SEWAGE DISPOSAL SYSTEM

MARYLAND STATE DEPARTMENT OF HEALTH

HOWARD COUNTY

Security Title #10747
 House Location
 7167 Deer Valley Road 7167 Deer Valley
W. J. CONNERS William J. & Jeanie M
PROPERTY
 Clarksville District
 Howard County, Maryland

PERMIT CARD

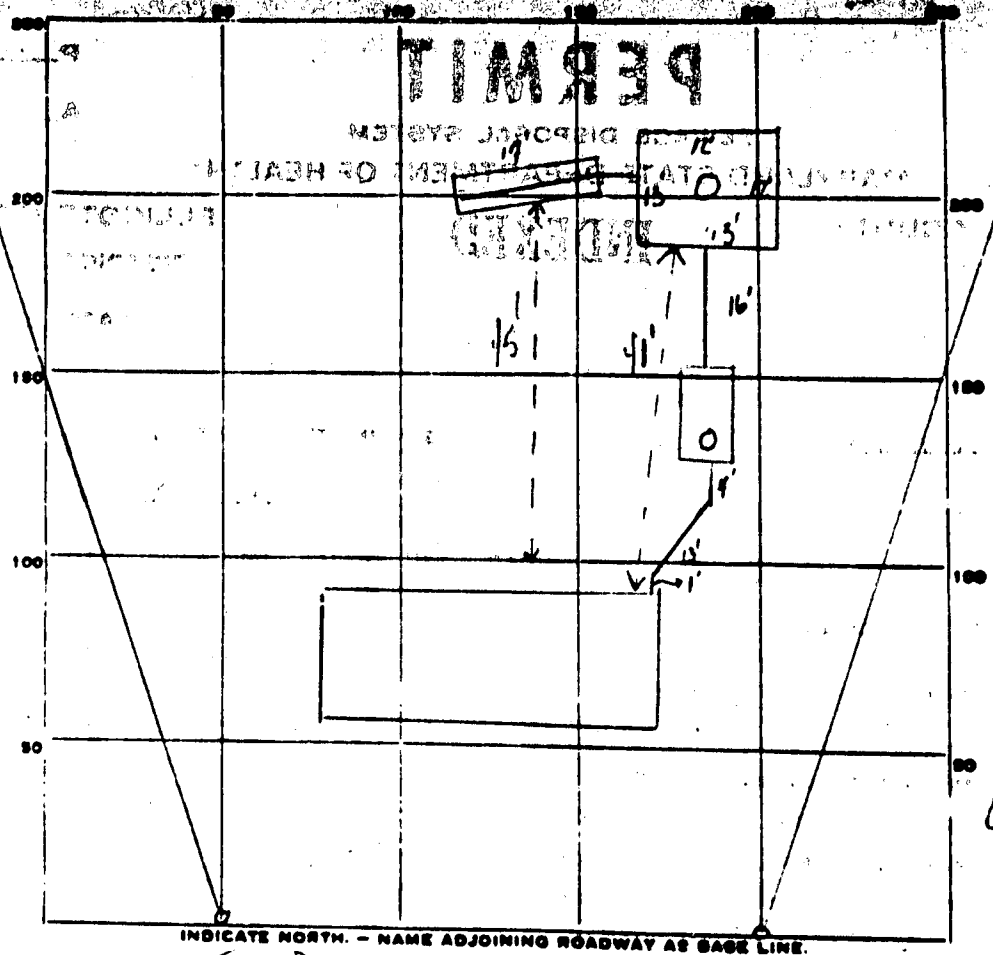
REMARKS: 20 lbs add gravel to trench SK+JS 7-29-80
 20 lbs add gravel to trench SK+JS 7-29-80

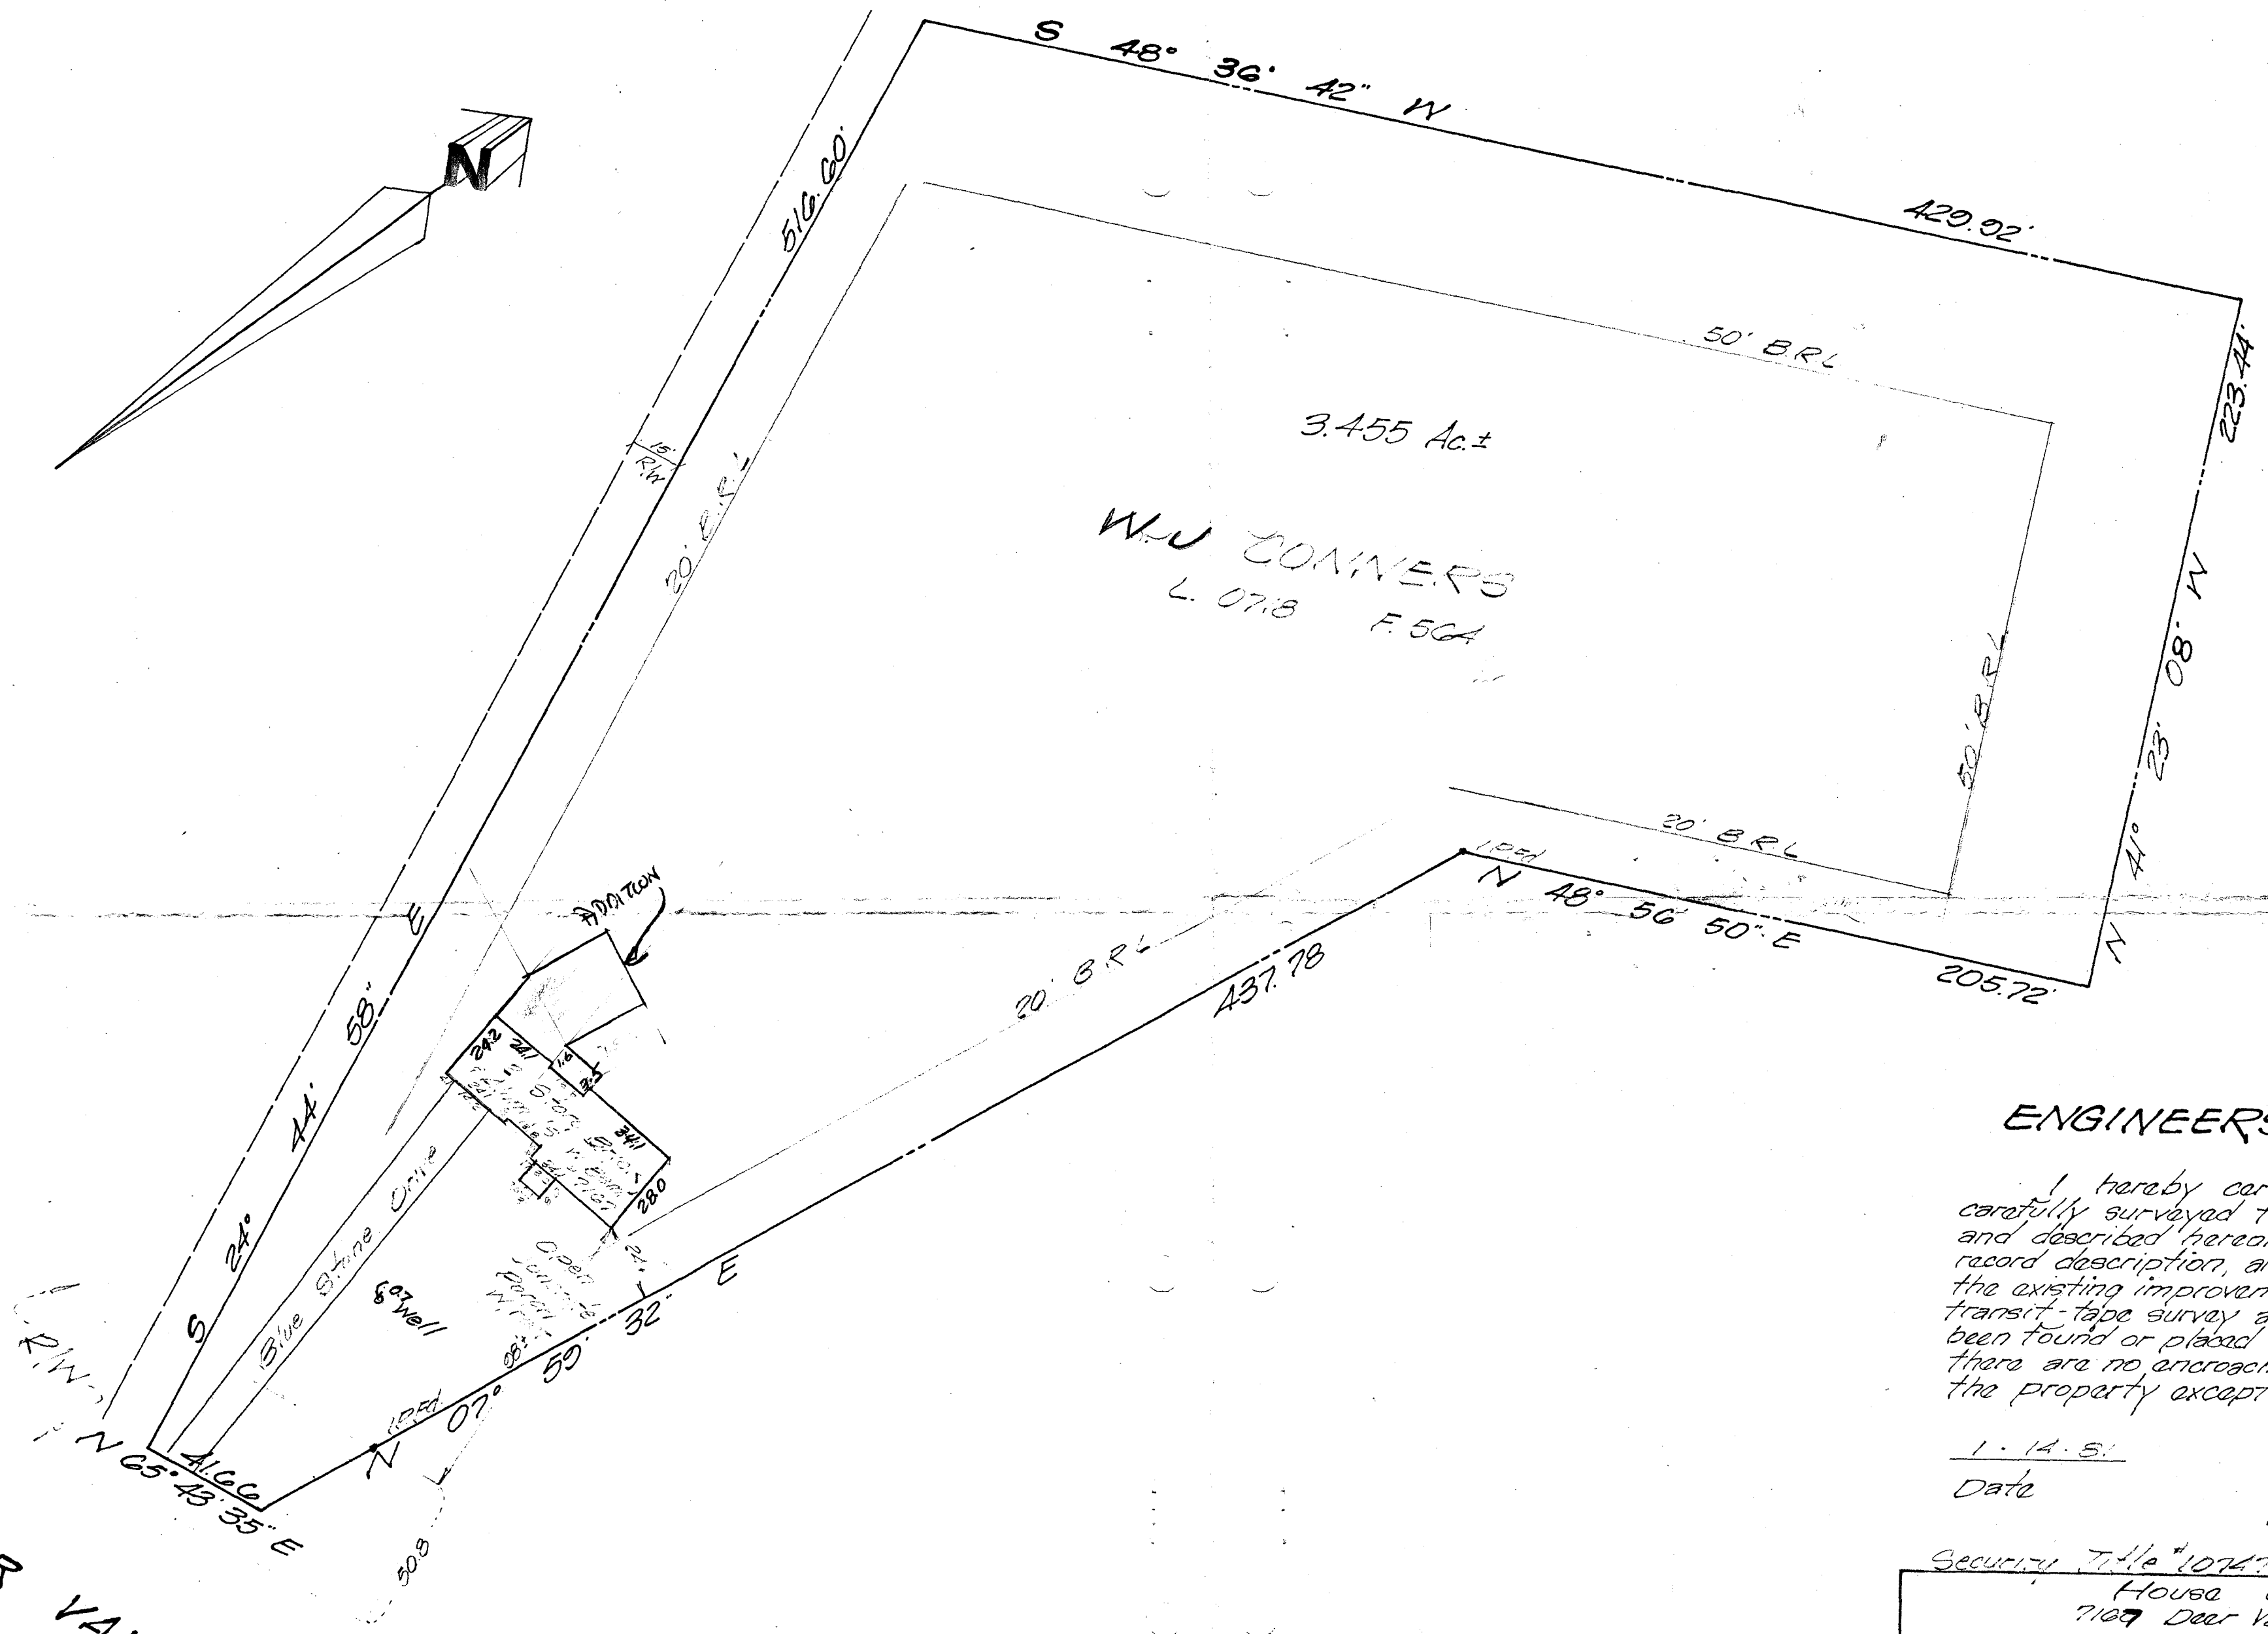
SEPTIC AREA DELETED BY THIS PLAN. 10K REMAINS ADDITION OK MR 4/20/98

4-28-98
 I MET WITH
 JACK CARBARY,
 CONTRACTOR, & EXPLAINED
 MINIMUM SEPARATION DISTANCES
 RELATIVE TO INSTALLED SEWER AND
 SDA. HE WAS GIVEN COPIES OF
 OUR RECORDS TO DEVELOP A BETTER
 SITE PLAN, AND MAY ELECT TO
 RE-PEC THE LOT FOR THIS
 ADDITION. *EL*
